## **Response to submissions – Minto Resource Recovery Facility (SSD 7462)**

This letter responds to the items raised in the *Bingo Resource Recovery Facility, 13 Pembury Road, Minto (SSD 7462) Request for Response to Submissions*, issued on 22 August 2017 and 14 February 2018.

**RE: 13 PEMBURY ROAD, MINTO  
SWEEP PATH ANALYSIS – RESPONSE TO DEPARTMENT OF PLANNING**

By: Lalaine mahlman  
Date: 2 February 2018  
Filename: 1501624019-Swept Path and Stacking-180202.dwg

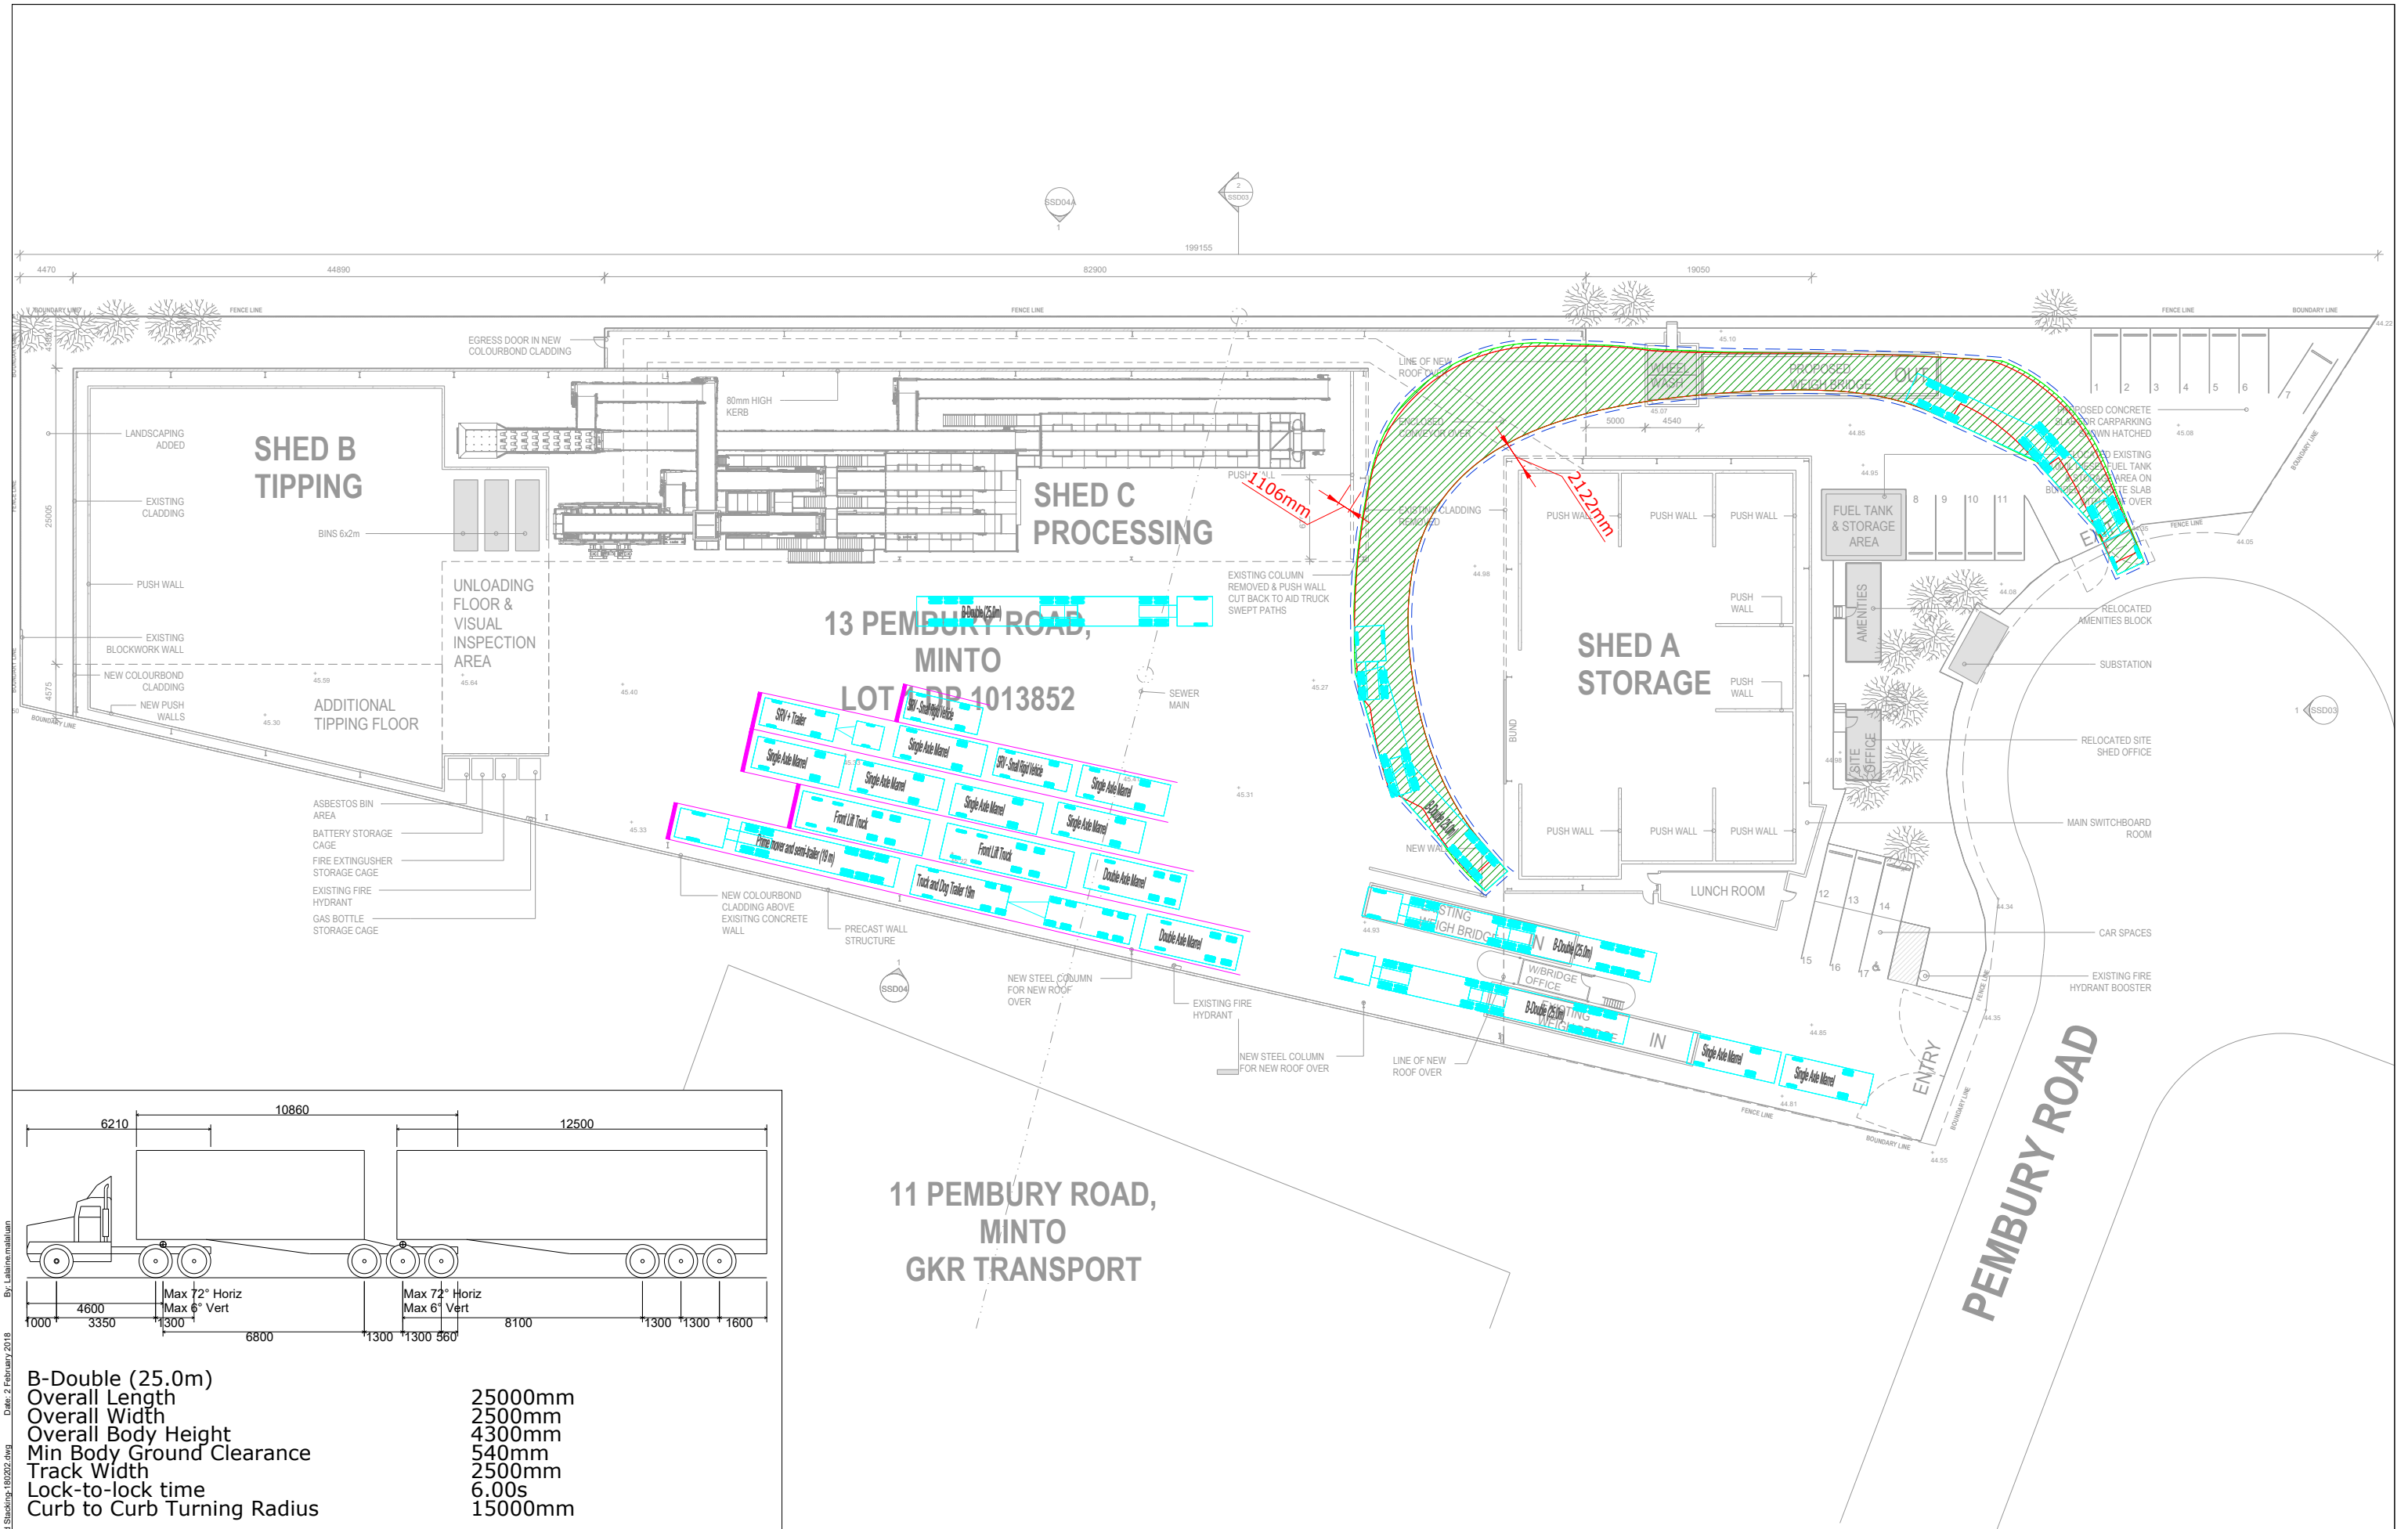
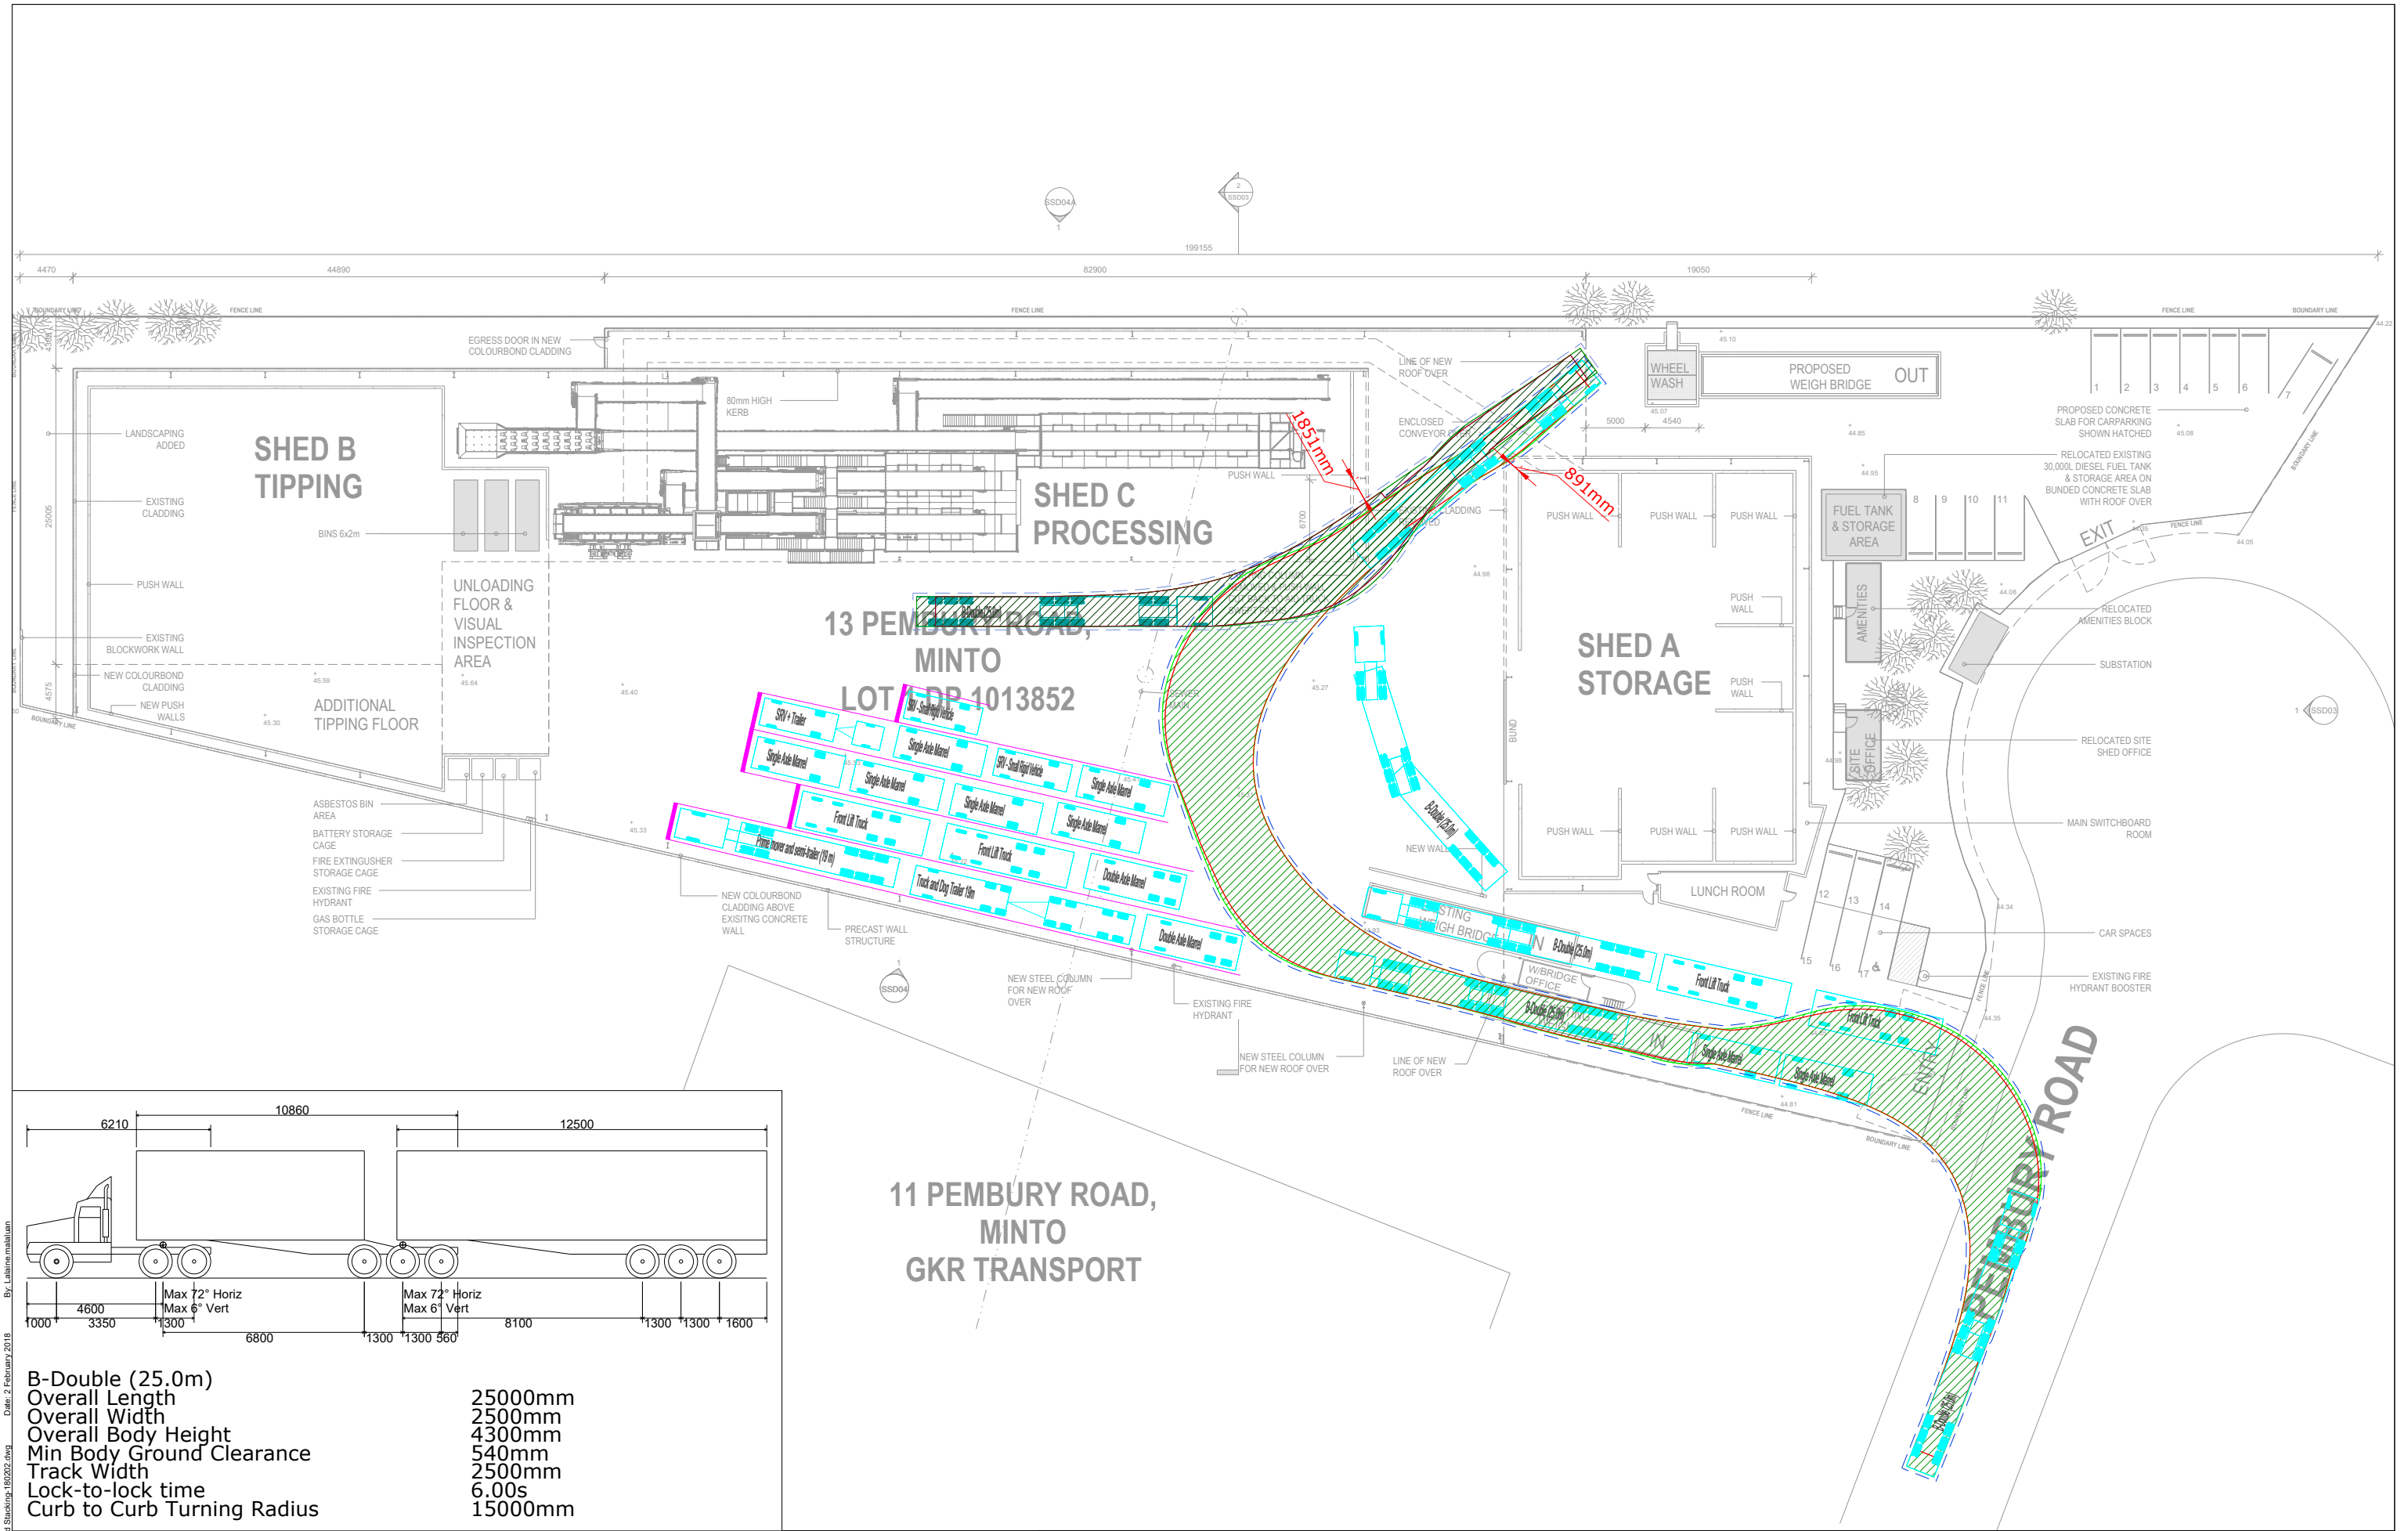
<p>At our meeting of 24 January, the Department expressed concern that the swept path diagrams for waste collection trucks will be too tight. Consideration should be given to scheduling waste collection by 25 metre trucks to outside of the early morning peak unloading period to avoid conflicts with other vehicles on-site and the</p>	<p>A technical memo has been prepared addressing this concern and demonstrating adequacy of on-site swept paths. The technical memo has been appended to this document as Attachment D.</p> <p>Following discussions between Department of Planning and Environment and the Site Operator, waste collection activities by B-double trucks will be scheduled to occur outside of the site peak operation. Waste collection by B-doubles will take place after 3:00pm and before 10:00pm each day.</p>	<p>Attachment D of this document</p>

As requested, please find herein The Transport Planning Partnership's (TPPP) response to Department of Planning and Environment's query regarding 25/26m B-double truck swept paths internal to the site located at 13 Pembury Road, Minto.

An analysis of swept paths for a 25/26m B-double truck with 15m turn radius has been undertaken using a forward manoeuvring speed of 10km/h and reverse manoeuvring speed of 5km/h. In accordance with Australian Standards, a 0.3m clearance shall be provided on both sides of a vehicle undertaking low speed manoeuvres (AS 2890.2, Clause 5.4). These clearances are shown as broken lines on the swept path plans contained in Attachment One of this letter.

In addition to the minimum required 0.3m clearance, the swept path analysis indicates that a B-double truck is able to manoeuvre on site with an additional clearance of up to 2.791m to physical obstructions. Additional clearances, on top of the standard 0.3m, are shown on the swept path plans contained in Attachment One. A summary of these extra clearances is provided in Table 1.

Swept Path Plan Reference	Description	Clearance to Shed A (Right side of Vehicle)	Clearance to Shed C (Left side of Vehicle)
Figure 1	25m B-Double Swept Path via Inbound Weighbridge (1) Inbound Movement	2.274m	1.347m
Figure 2	25m B-Double Swept Path via Inbound Weighbridge (1) Outbound Movement	2.122m	1.106m
Figure 3	25m B-Double Swept Path via Inbound Weighbridge (2) Inbound Movement	2.700m	1.342m
Figure 4	25m B-Double Swept Path via Inbound Weighbridge (2) Outbound Movement	2.122m	1.106m
Figure 5	25m B-Double Swept Path via Inbound Weighbridge (1) Inbound Movement	0.891m	1.851m
Figure 6	25m B-Double Swept Path via inbound weighbridge (1) Outbound Movement	2.791m	0.904m
Figure 7	25m B-Double Swept Path via Inbound Weighbridge (2) Inbound Movement	2.432m	1.258m
Figure 8	25m B-Double Swept Path via Inbound Weighbridge (2) Outbound Movement	2.791m	0.904m

The above summary indicates that there will be, at least, 0.891m clearance to any physical obstructions on top of the standard 0.3m clearance. This is measured on the left side of the vehicle as it reverses into position alongside Shed C.

The swept path analysis demonstrates that a B-double truck will always have a clearance equal to or greater than 1.191m (0.891m + 0.3m) measured between the vehicle body and a physical obstruction along its travel path between Shed A and Shed C.
